SITE PLAN WAIVER REQUEST REVIEW SHEET

CASE: SP-2010-0131C

PROJECT NAME: Jae Park Project

SITE PLAN

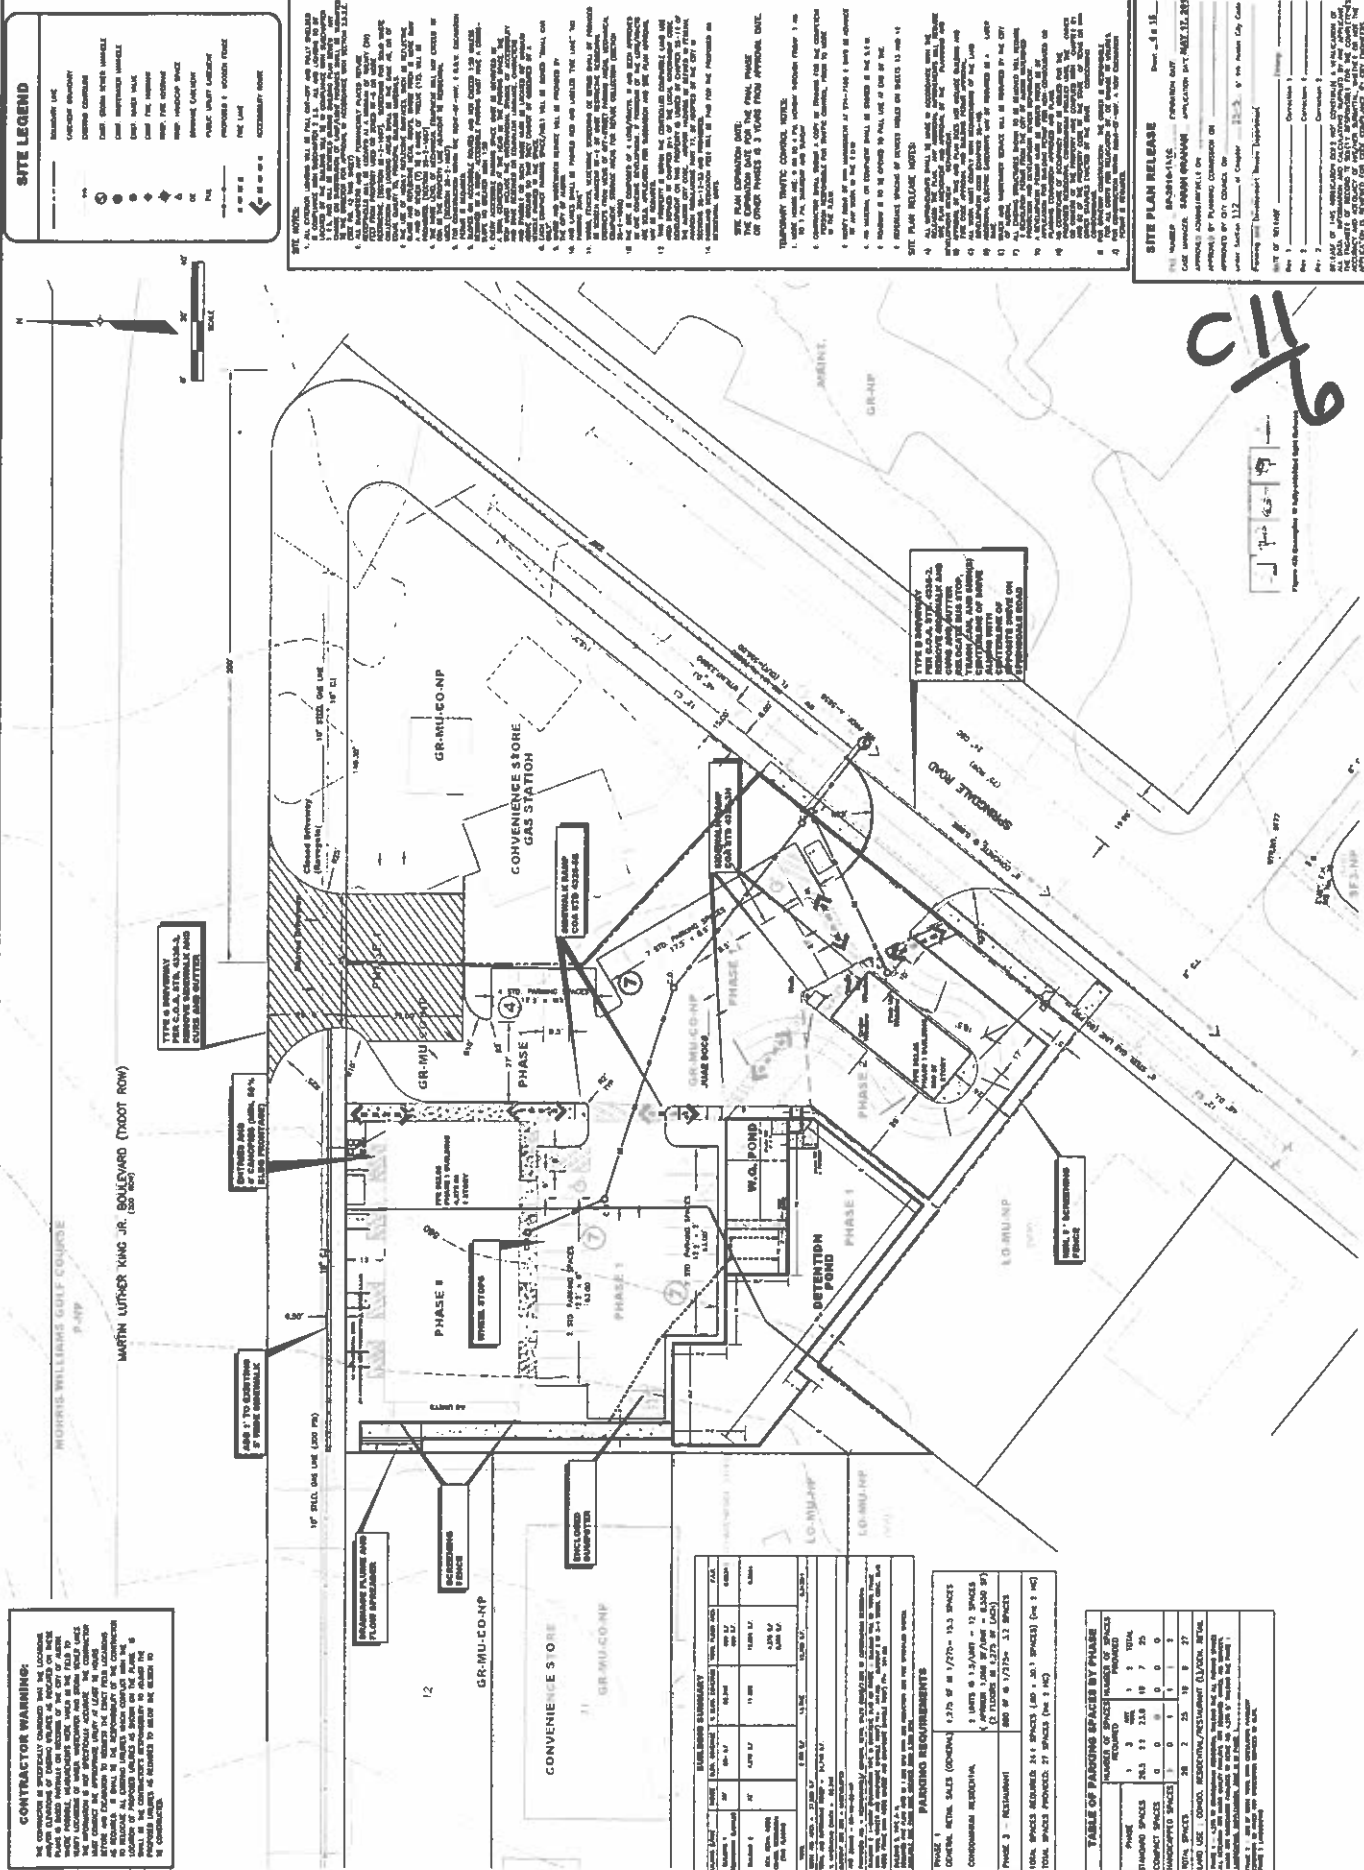
The applicant requests a waiver from Land Development Code Section 25-2-1067(H) - All parking areas and driveways shall maintain a setback of 25 feet from property lines adjacent to an SF-5 or more restrictive use or district. The applicant is currently proposing a 5 foot setback line for an associated drive-through lane. Staff supports this waiver request as the affected property owner located at 1806 Springdale Rd has demonstrated support for the waiver request – see the attached letter for further information. The applicant is proposing to locate a 6 foot fence along the property line and add some landscaping to buffer any noise and light pollution.

The applicant requests a waiver from Land Development Code Section 25-2-1063(B)(2) - A person may not construct a structure 25 feet or less from property on which a use permitted in an SF-5 or more restrictive zoning district is located. The applicant is currently proposing a setback no less than 23 feet for a one-story building and a setback of 5 feet for the associated detention pond. Staff supports this waiver request as the affected property owner located at 1806 Springdale Rd has demonstrated support for the waiver request – see the attached letter for further information. The applicant is proposing to locate a 6 foot fence along the property line and add some landscaping to buffer any noise and light pollution.

Staff recommends approval of waivers from LDC Section 25-2-1067(H) and 25-2-1063(B)(2) to allow the applicant to construct a building no less than 23 feet from the SF-used lot to the southwest, a detention pond with a 5 foot setback from the SF-used lot, and a 5 foot setback line for an associated drive-through lane from the SF-used lot.
